Project	IEEE 802.16 Broadband Wireless Access Working Group < http://ieee802.org/16 >	
Title	Action Item from Session #46: Consolidation of UCP – Uncoordinated Coexistence Protocol	
Date Submitted	2007-01-08	
Source(s)	Paul Piggin NextWave Broadband Inc. 12670 High Bluff Drive San Diego CA 92130 USA	Voice: 1 858 480 3100 Fax: 1 858 480 3105 ppiggin @ nextwave.com
Re:	Working Group Letter Ballot #24 for IEEE P802.16h/D1.	
Abstract	This document contains proposed editorial and technical changes to sub clause 6.4.2.4 ‘ <i>Uncoordinated Coexistence Protocol (UCP)</i> ’ and associated sub clauses. A number of comments from Working Group Letter Ballot #24 considered at Session #46 are related to this clause. This document addresses these comments and suggests a harmonization of the comments presenting accompanying editorial instruction to implement the changes.	
Purpose		
Notice	This document has been prepared to assist IEEE 802.16. It is offered as a basis for discussion and is not binding on the contributing individual(s) or organization(s). The material in this document is subject to change in form and content after further study. The contributor(s) reserve(s) the right to add, amend

Figure h2a Flowchart showing generic operation **at the BS** in bands with **SSUs-specific spectrum users** [Note: revised figures]

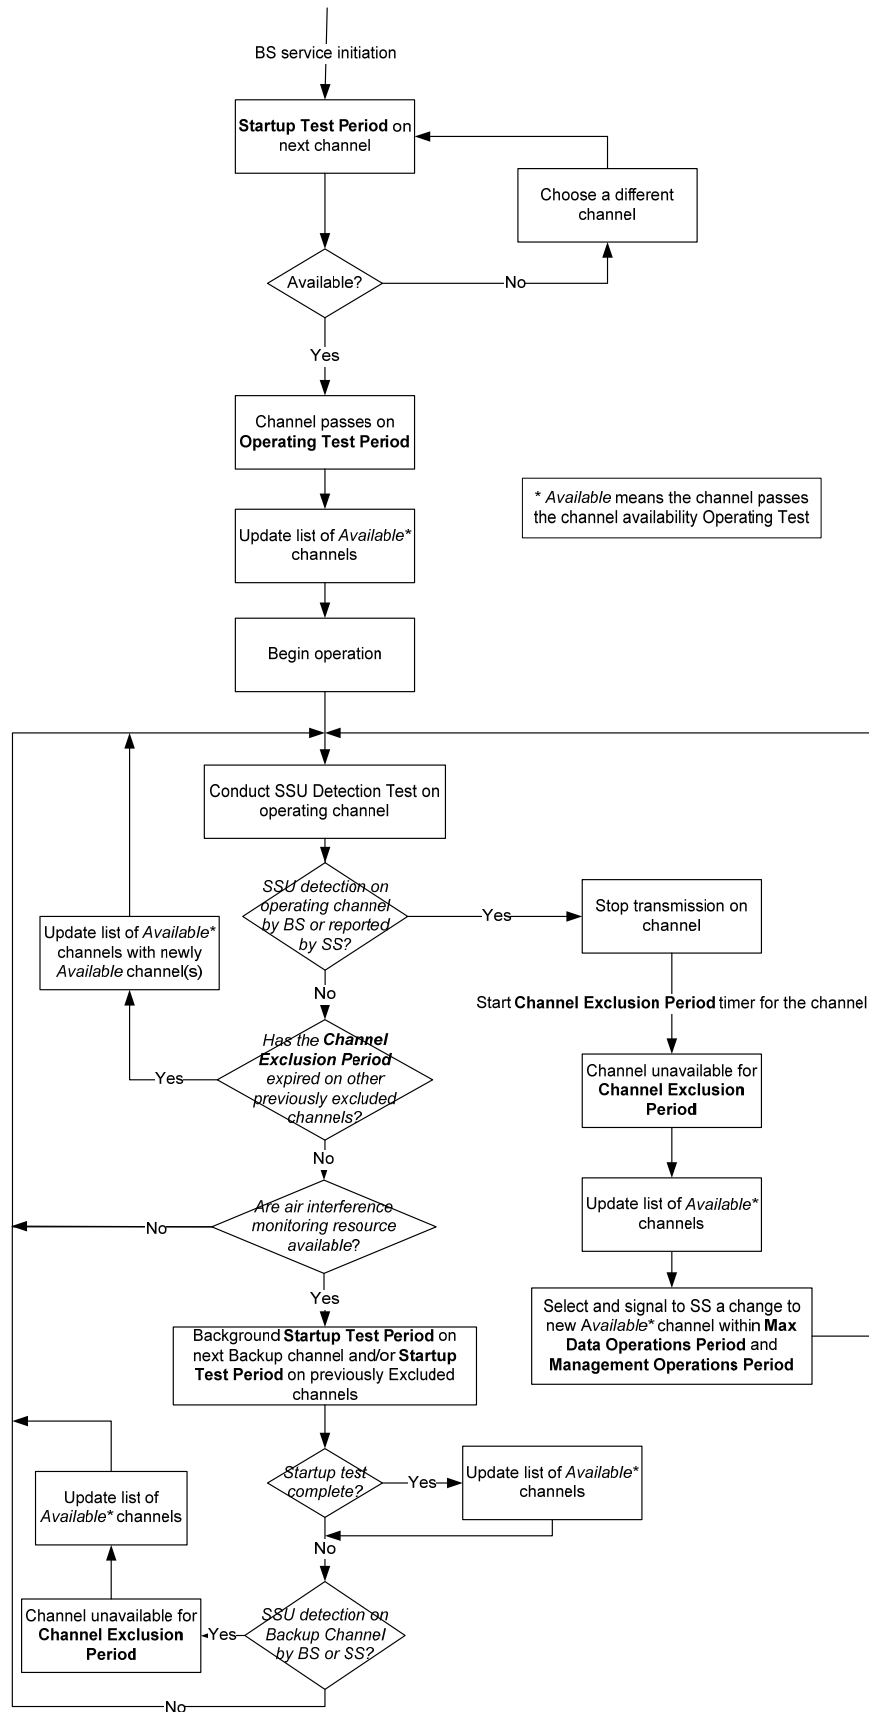
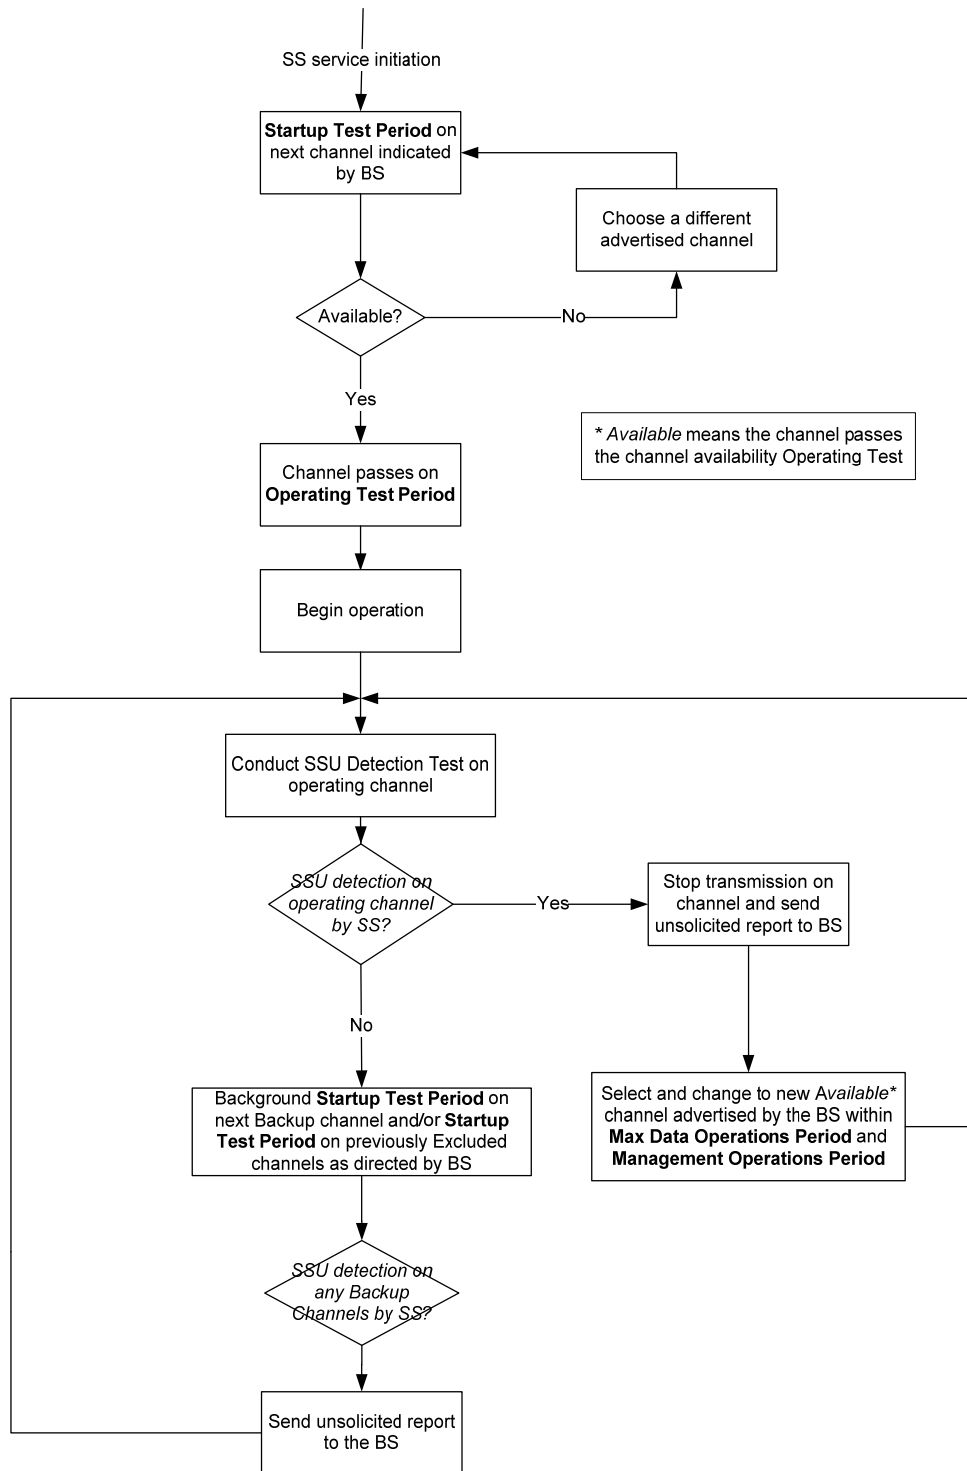
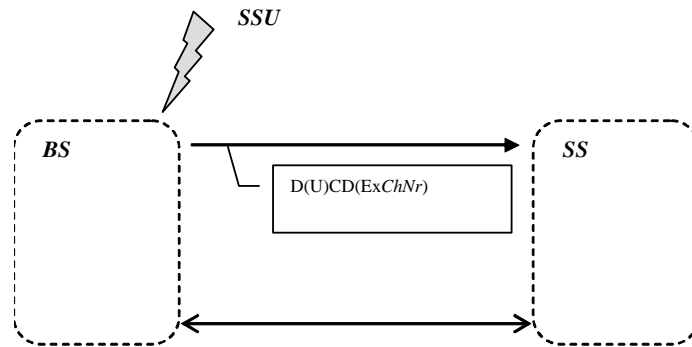
The coexistence mechanism described here should actually be implemented by both BS and SS. The diagram and the description miss the required operation when a "SSU" is detected by either the BS or SS. Namely the change to an alternative channel. In fact both BS and SS should scan the alternative channel constantly to ensure that the BS and any of the SS hasn't changed to that channel. If any SS or BS detect the interference they should immediately stop transmission, so they cannot notify any of the other parties about the change,

Correct the diagram to include scanning of the alternative channel and the hopping to the other channel.

It is not mentioned whether the mechanisms of the flowchart are applicable to both UL and DL

We should never get to the decision point "Channel Exclusion Period expired?" if the result would be false. The decision is in the wrong place in the flowchart. The timer can either be thought of as a separate parallel process (reality), or can be something that is periodically checked, in which case it should be part of the process of selecting a new channel in the box at the right-hand side around lines 46-48. Also, the starting of the channel exclusion period timer at line 36 is too simplistic because, as written, if any channel has an SSU detected then no channels are useable. Rather, there should be an independent exclusion timer for each channel on which an SSU is detected.

Fix the diagram to properly handle the exclusion timer. There are many ways to do this included what is described above.

Comment 116: Avi Freedman: Remedy suggested.

Comment 117: David Grandblaise: Remedy suggested.

Comment 125: Ken Stanwood: Remedy suggested.

Figure h2 provides an illustrative flowchart of a generic scheme for operation in bands with SSUs. The flowchart highlights the main operational requirements for coexistence and overviews the description in the remainder of this sub clause. [Figure h2a illustrates possible behavior at the BS, while Figure h2b illustrates the behavior at the SS. Figure hxyz1 provides a link level example of message exchange in the event an SSU is detected at \(a\) the BS, and \(b\) the SS.](#)

Figure hxyz2a Flowchart showing generic operation at the BS in bands with non-SSUs only

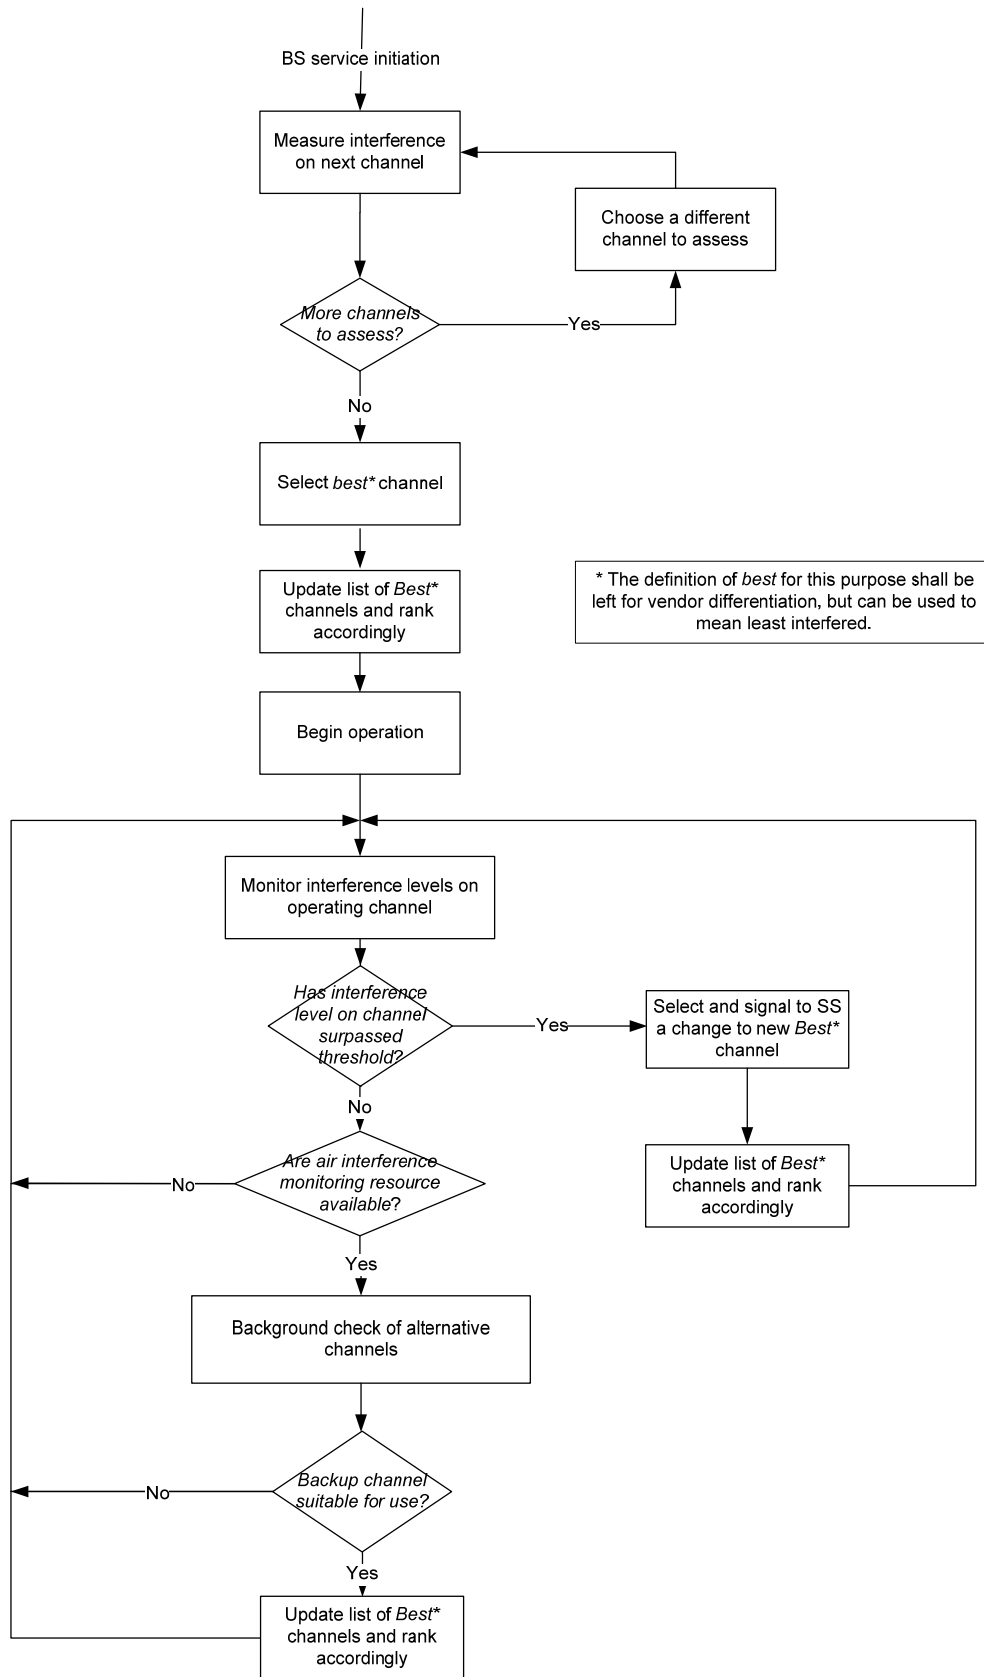
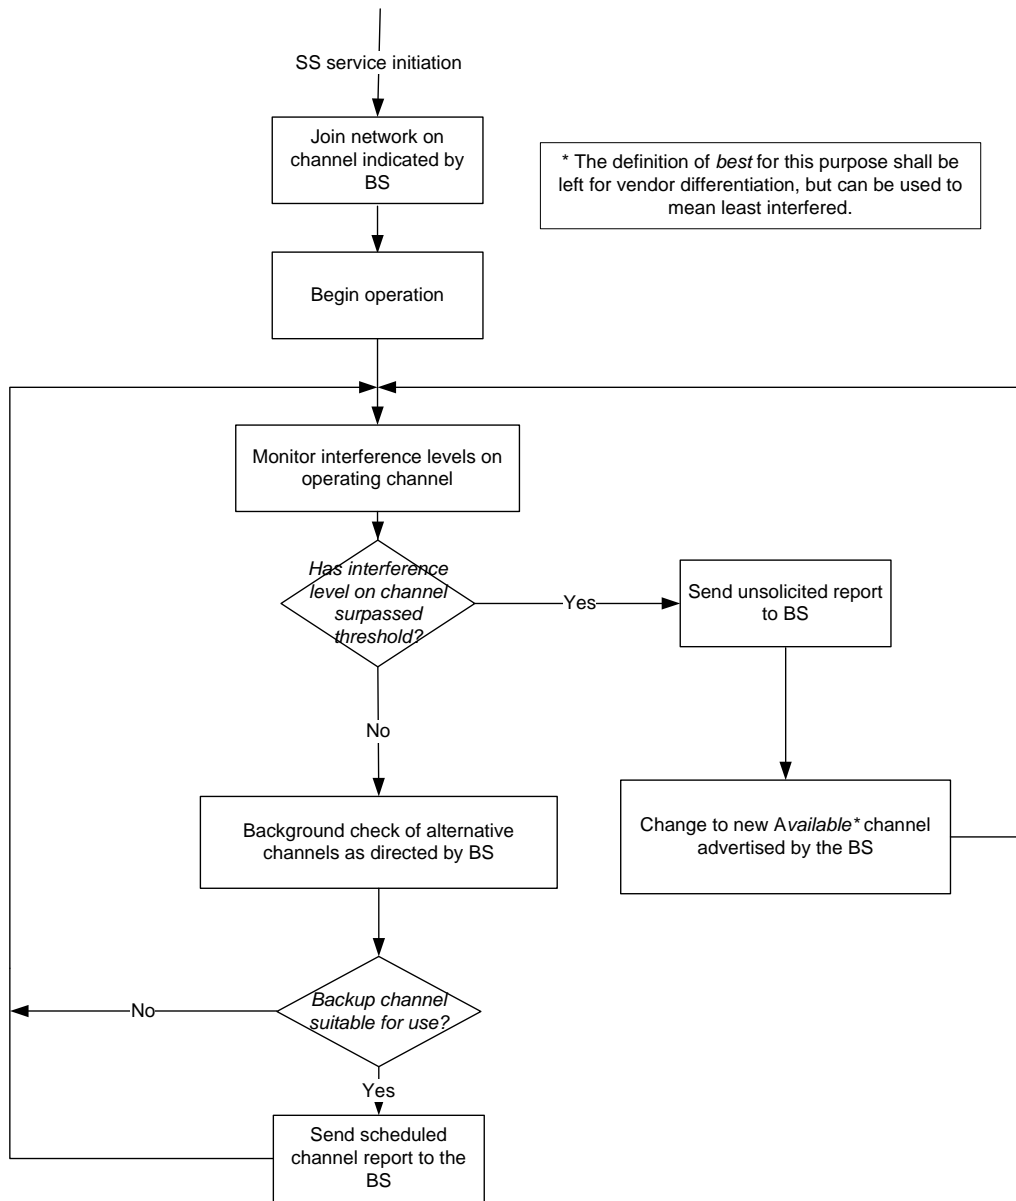
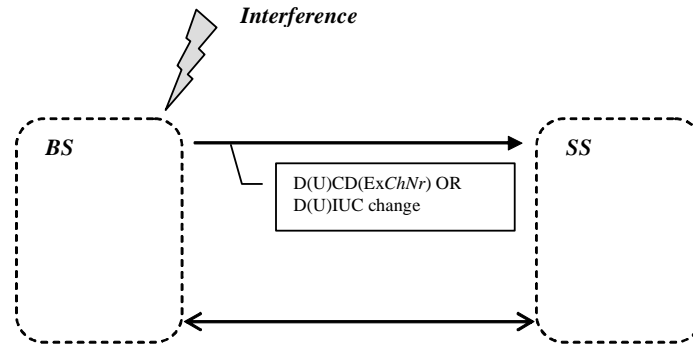
Dynamic Channel Selection (DCS) is ~~a realization of~~ an uncoordinated coexistence mechanism and provides the ability for a system to switch to different logical physical frequency channel, based on channel measurement conditions, and ~~thus thereby~~ avoiding interference in non-exclusively assigned and non-exclusively licensed bands. ~~Logical channels can be constructed from an operating frequency and time component, or a portion thereof. Channel measurement and interference avoidance provide a DCS algorithm with the means of obtaining interference isolation in time and frequency. This approach enables a number of systems to share a given frequency. The approach contrasts to that of subclause 6.4.2.2., which specifies SSUs avoidance in which the physical frequency is vacated due to the potential interference to the SSU.~~ DCS can be used as a means of finding a least interfered channel at system startup or can be used during normal system operation to provide constant interference monitoring capabilities and, with the ability to monitor other channels, provide a list of backup channels for informed switchover to a different, less interfered, channel. An illustrative example is given in Figure hxyz2a for possible behavior at the BS, while Figure hxyz2b illustrates the behavior at the SS.

Figure h3—Link level representation of DCS operation

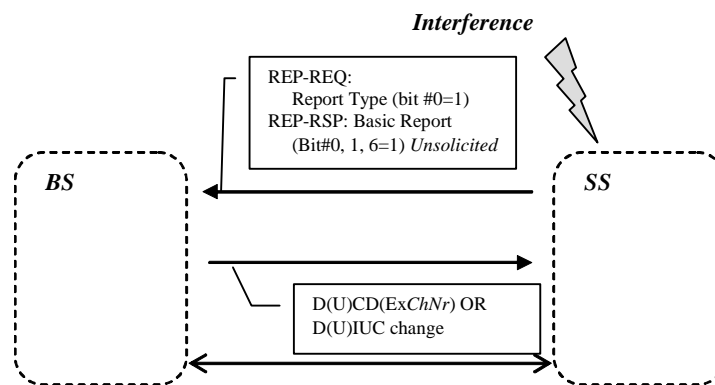
A general example of a DCS solution is provided in *Figure h3* in which interference detection results in a channel change. ~~provides agility in frequency and time to reduce the effects of the incident interference. Figure h3 (a) indicates the events that occur following happen after~~ interference is detected ion at the BS. ~~Since the interference is deemed not to be an SSU, and therefore not protected by regulation, t~~ The DCS algorithm has the choice to either clear the channel (as would be required for the detection of an SSU) or find a less interfered area of the frame has a choice to either vacate the channel or overcome the interference by using a more robust modulation scheme. The DCD/UCD, containing the ExChNr (6.4.1.2), is used to make the channel change,

~~while the DL MAP/UL MAP provides a change of location in the frame.~~ A similar procedure is followed for interference detection at the SS, illustrated in *Figure h3* (b), however in this case the REP-RSP, sent by the SS in an unsolicited manner, initializes the ~~messaging undertaken~~response by the BS.

Figure hcup1 Flowchart showing generic operation of UCP at the BS in bands with SSUs and non-SSUs

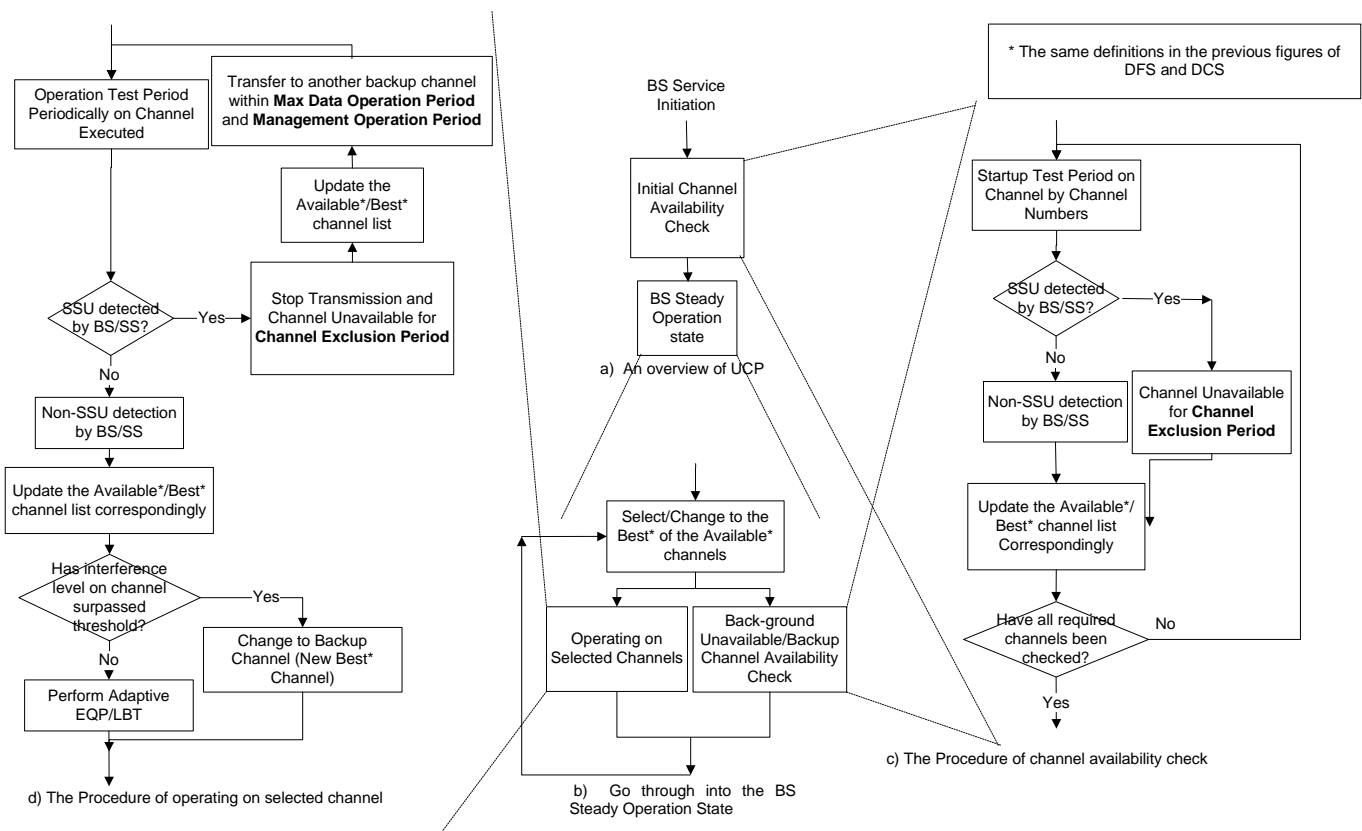
Upon system startup, the BS shall choose a suitable channel in which to operate. perform DFS/DCS Channel selection will depend upon the requirements for operation in a given band. to choose the channel on which to operate. If the band has SSUs, the BS shall use DFS to find a channel free of SSUs. DCS shall be used to choose the best channel that not occupied by a SSU. The definition of best for this purpose shall be left for vendor differentiation. If the band contains SSUs, the BS shall use a protocol termed in this sub clause 'DFS' to attempt to find a channel free of SSUs; this protocol is described in sub clause 6.4.2.2. If the band contains only non-SSUs, the BS shall use the DCS protocol to find the *best* channel for operation; this protocol is described in sub clause 6.4.2.2. The definition of *best* for this purpose shall be left for vendor differentiation, but can be used to mean least interfered. If the band contains both SSUs and non-SSUs then both DFS and DCS protocols are used together. The DFS protocol is used to avoid interference to SSUs by vacating the channels on which SSUs are detected, and additionally DCS is used to select the *best* channel of the set of channels in the band that are eared for operation by DFS.

The BS shall continue to perform DFS and DCS operation, as required, selecting the most appropriate channels based on the prevailing conditions and reacting to reported measurements from the SSs. For the case SSUs are detected on a channel then the DFS protocol shall attempt to select an alternative channel. For the non-SSU detection the BS shall use the DCS protocol in order to select an alternative channel, previously checked to be clear of SSUs, or shall ~~The BS shall implement use adaptive~~ aEQPs, as described in sub clause 6.4.3.3, to ensure other detected systems have an opportunity to transmit. ~~The BS shall require measurement and reporting from the SSs per the DFS/DCS protocol, and move to a better channel should one come available.~~ Also if systems other than ~~other 802.16 systems and~~ SSUs are ~~may be~~ present in the channel, the BS shall use the listen-before-talk (LBT) protocol of sub clause 6.4.3.5 to avoid scheduling a frame when another system is transmitting on the channel. Flowcharts representing this operation are given in Figures hcup1 and hcup2 for the BS and SS respectively.

Figure h7—~~listen-before-talk~~LBT [Note: revised figure]

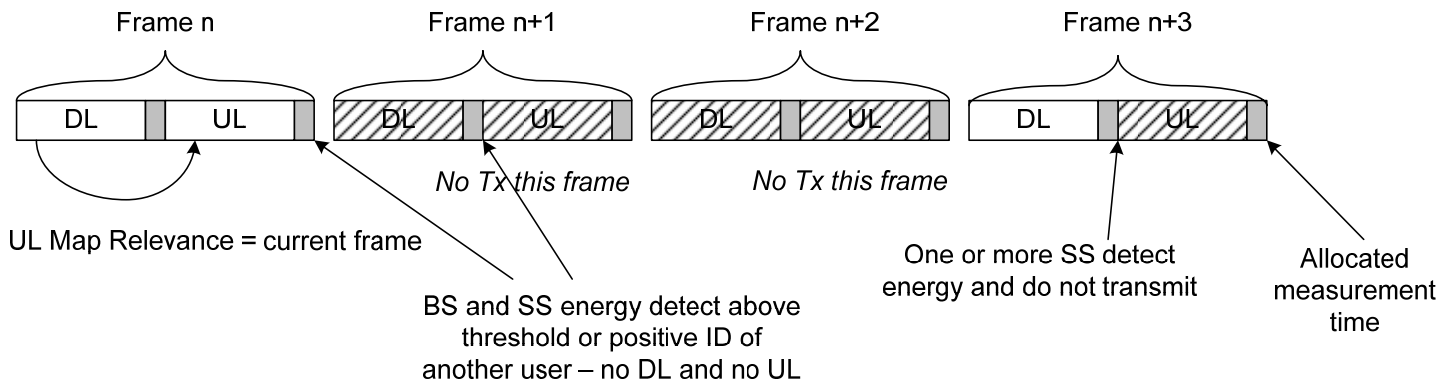
The proposed mechanism violates the OFDM and OFDMA Frame structure, by introducing silence periods at and eliminating preambles, FCH, MAPs etc.

The proposed mechanism violates the coexistence rules established between 802.16h users, as the interference-free periods provided by the Master sub-frames

The proposed mechanism violates the OFDM and OFDMA Frame structure, by introducing silence periods at and eliminating preambles, FCH, MAPs etc. LBT does not violate OFDM/OFDMA frame structure. It is right and proper to introduce quiet periods and make interference assessment by way of *channel measurement IE* (8.4.5.3.5). Preambles, FCH and MAPs are still present.

The proposed mechanism violates the coexistence rules established between 802.16h users, as the interference-free periods provided by the Master sub-frames: There is no violation for coexistence rules between 802.16h users. There is nothing that requires WirelessMAN-CX systems to implement LBT. It seems from previous discussion that aEQP and LBT is a means of facilitating WirelessMAN-CX systems.
